# A205 Thurlow Park Road / Rosendale Road Cycle Network Development Proposals

Stage 1 Road Safety Audit

Ref: 4176/009/A205/TLRN/2023

**Location:** A –Thurlow Park Road- Eastbound junction Approach.

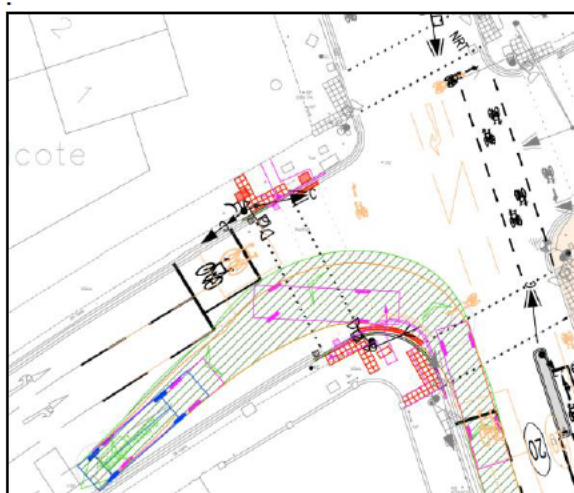
**Summary:** Risk of vehicle / road user collision due to Pantechicon vehicle turning left out of Rosendale Road (south Arm) passing close to eastbound junction approach.

The drawing indicates that the swept path of a Pantechicon vehicle would pass close to the ASL and vehicle stopline on the eastbound junction approach. Marginal lateral clearance between cyclists in the ASL and vehicles (especially larger vehicles) at the stopline to vehicles turning left creates the potential risk of road users being struck by a large turning vehicle. Cyclists and motorists waiting at the eastbound stoplines may not expect a vehicle to pass close by to complete its manoeuvre.

Ensure all anticipated vehicle types can complete this left turning manoeuvre without over-running the eastbound ASL and vehicle stopline.

Design Organisation Response	Accepted
The design did not require any revisions and the vehicle tracking for a Pantechicon vehicle at 5mph was carried out for a second time, showing that the left turning manoeuvre does not over run the eastbound ASL or the vehicle stop line.	
Client Organisation Comments	
Noted.
